Subject	Response to HydroGeoLogic Groundwater Review	Project Name	Bowdens Silver Project
Attention	Paul Ryal (RWC)	Project No.	IA132500
From	Greg Sheppard		
Date	15 December 2021

The following Memo provides a response to review comments provided by HydroGeoLogic on behalf of the NSW Department of Planning Industry and Environment, of the Bowdens Silver Updated Groundwater Assessment. The review is dated 12 July 2021.

Figure 1: BGW108 pumping response (Figure 26a of the Amended Groundwater Report)

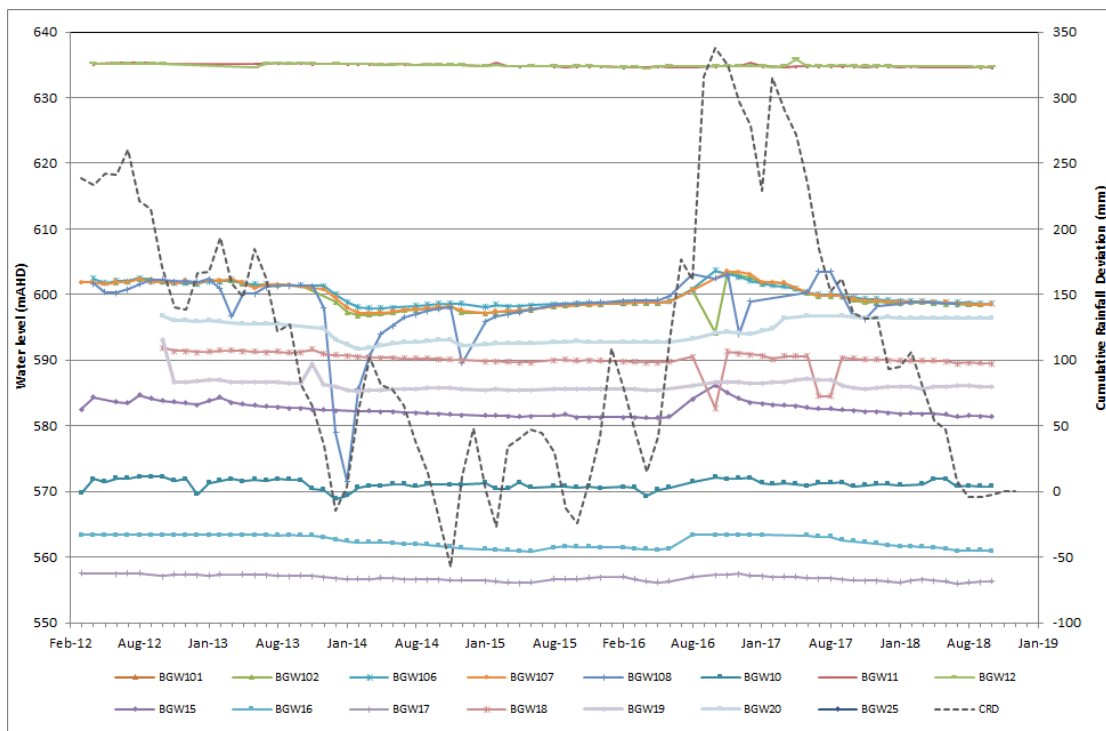
The question of whether the model performance is 'very good' where it needs to be, in the Bowdens mining area, is not comprehensively answered by the reports.

Considerable time and effort was spent on achieving a good calibration in the mining area. A key component of this calibration effort was in matching the observed water level response at bore BGW108, which is situated in-pit, during a period of continuous pumping from late 2013 and early 2014.

Figure 26a of the Updated Groundwater Assessment, reproduced below as **Figure 1**, illustrates the observed drawdown and recovery response for this bore during the period of pumping. The response is also observed at BGW102, BGW106, and BGW107. **Figure 2** below presents the results of transient calibration for BGW108. This figure is included in the reporting and clearly shows a good match between the model results and the observed fluctuation at BGW108, demonstrating that the model is suitably calibrated in the Bowden mining area.

Figure 3: Extent of drawdown propagation (1m contour)

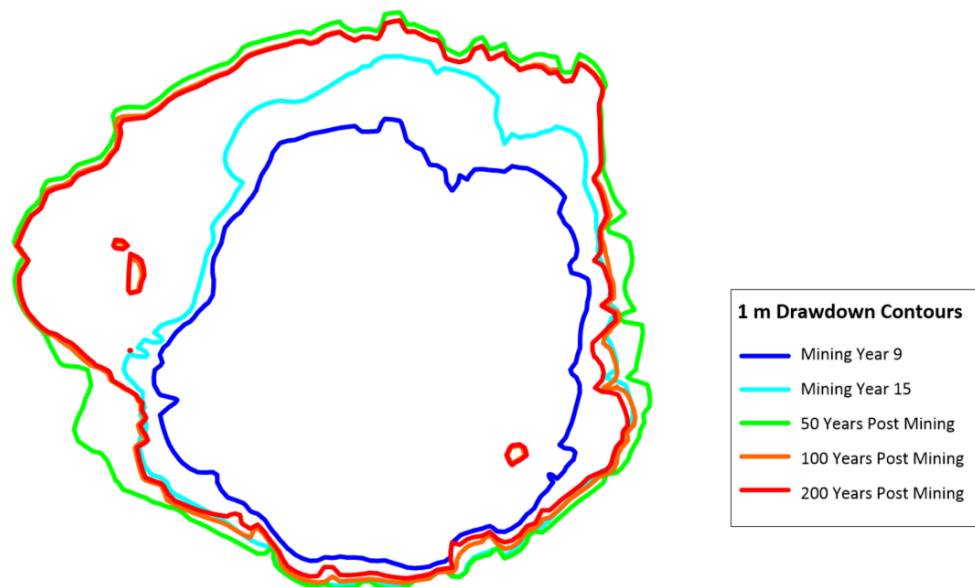
The maximum extent of drawdown impact does not occur by 16 to 50 years post-mining (UGA section 6.2.4), as other results indicate that time frame should be about 150 years (UGA Figure 48);

The assessment as presented in the Amended Groundwater Assessment still stands. The maximum extent of drawdown propagation and the equilibration of the final pit lake are not necessarily contemporary occurrences. The cone of drawdown will expand until the rate of groundwater inflow from the perimeter of the cone of drawdown, plus any recharge within the area of the cone of drawdown is equal to the rate of groundwater extraction. Depending on formation hydraulic properties and rate of recharge there is potential for this to occur during mining, at the end of mining or shortly after cessation of mining, as is the case for Bowdens.

The reviewer is suggesting that the maximum extent of drawdown would correspond with pit lake equilibrium, when in fact the cone of drawdown would diminish in area and volume at pit lake equilibrium.

Figure 3 shows the extent of drawdown propagation during and after mining and **Figure 4** presents the area encompassed by the 1m drawdown contour. It is noted that **Figure 4** is in Years from commencement of mining, so 50 years post mining is plotted at Year 66, and so on. As can be seen from **Figure 3**, the maximum extent of propagation is around 50 year post mining, with minor contraction of the 1m contour at 100 and 200 years post mining. Importantly, with respect to potential impacts to other groundwater users or sensitive environmental receptors, no additional impacts will occur post 50 years of mining that are not already captured by the impact assessment.
